Your Reference: P0064655
Enquiry Phone: Customer Service 07 3412 5269
Property Key: 305559
Document Number: 19744170
Please Quote: COM/59/2026
File Number: 1487221-1

INFORMATION REQUEST

APPLICATION NO: COM/59/2026
PROPERTY ADDRESS: 377 BEAUDESERT BEENLEIGH ROAD, WINDAROO QLD 4207
PROPERTY DESCRIPTION: LOT 15 RP 839315
APPLICATION DESCRIPTION:
• **COMBINED APPLICATION - MATERIAL CHANGE OF USE (FOOD AND DRINK OUTLET), RECONFIGURING A LOT (1 LOT INTO 2 LOTS), AND OPERATIONAL WORKS (ADVERTISING DEVICES)**

Figure 2:

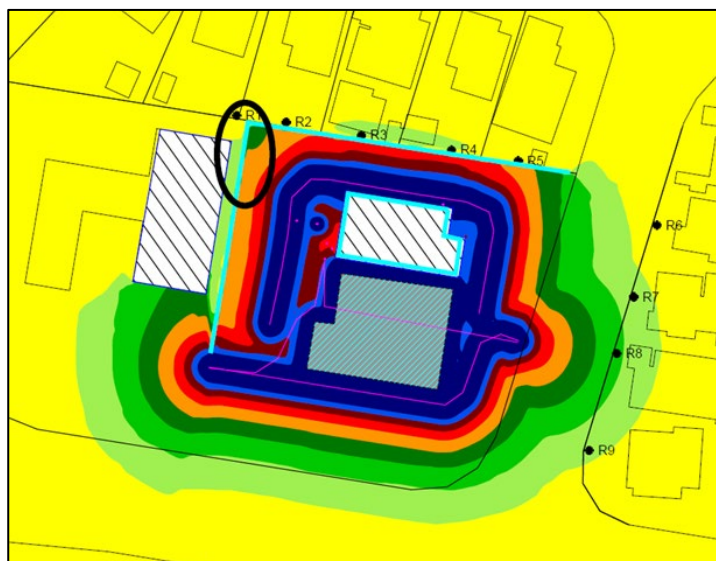
- 3.1. Clarify whether the existing acoustic barrier must be maintained to comply with Council's noise limits.

The figure shown on page 50 of the submitted Noise Impact Assessment indicates that the southernmost section of the barrier has not been modelled; however, the northernmost section of the existing acoustic barrier, identified in Figure 2 below, may need to be retained to ensure compliance with Council's noise limits and prevent noise leakage to the existing sensitive receivers to the north of the subject site.
